Proposed Milton Quarry East Extension JART COMMENT SUMMARY TABLE – Groundwater Modelling

Please accept the following as feedback from the Milton Quarry Joint Agency Review Team (JART). Fully addressing each comment below will help expedite the potential for resolutions of the consolidated JART objections and individual agency objections. **Additional, new comments may be provided once a response has been prepared to the comments raised below and additional information provided.**

JART Comments (June 27, 2022)	Reference	Source of Comment	Applicant Response 2022	JART Response (June 2023)
Report/Date: Geology and Water Resources Assessment Report December 2021		Author: GHD			
Supplemental Questions Received June 27, 2022

Figure F7.3

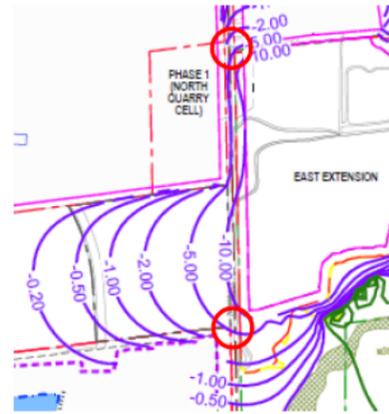
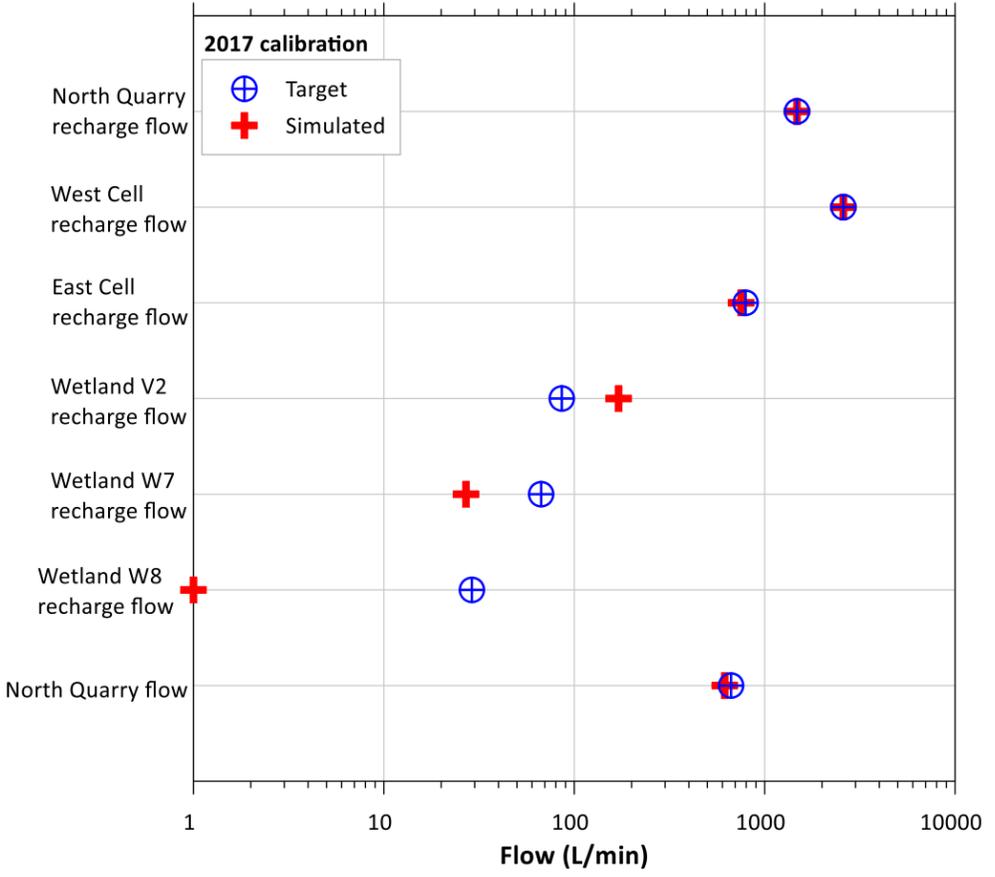
8.	<p>Referring to Figures 7.3 and 7.6, are we correct in understanding that the changes are calculated as follows? As shown in the two slides attached to this letter, it is not obvious from spot checks that this is how the results are calculated.</p> <p><u>Figure 7.3</u> Change = Simulated Layer 3 water levels for the approved existing quarry fully extracted - Simulated Layer 3 water levels for the approved existing quarry + MQEE fully extracted</p> <p><u>Figure F7.6</u> Change = Simulated Layer 3 water levels for the approved existing quarry rehabilitation - Simulated Layer 3 water levels for the approved existing quarry + MQEE rehabilitation</p>	Page F9	S.S. Papadopulos & Associates Inc.	<p>The changes are calculated opposite to your understanding. The change is calculated as described below for Figures F7.3 and F7.6</p> <p><u>Figure F7.3</u> Change = Simulated Layer 3 water levels for the approved existing quarry + MQEE fully extracted - Simulated Layer 3 water levels for the approved existing quarry fully extracted</p> <p><u>Figure F7.6</u> Change = (Simulated Layer 3 water levels for the approved existing quarry + MQEE rehabilitation) – (Simulated Layer 3 water levels for the approved existing quarry rehabilitation)</p> <p>See response to the two attached slides below to clarify the calculations.</p>	RESOLVED.

Appendix – Change calculations

Change calculation #1

Approved existing quarry fully extracted – Approved existing quarry + MQEE fully extracted

Upper point: 307 masl - ? = 5.0 m

Lower point: 319 masl – 311 masl = 5.0 m (?)

12.	Appendix – Change calculations Change calculation #1			The values selected in the comment for change calculation #1 are incorrect due to approximating head values from the coarsely spaced contours on Figures F7.1, F7.2, and F7.3. Please see appended Figures 4, 5, and 6 showing more finely spaced contours to clarify the calculation. Figures 4, 5, and 6 correspond to a zoomed in view around the East Extension for Figures F7.1, F7.2, and F7.3, respectively.	RESOLVED. The appended Figures 4, 5 and 6 are added to the project documentation.
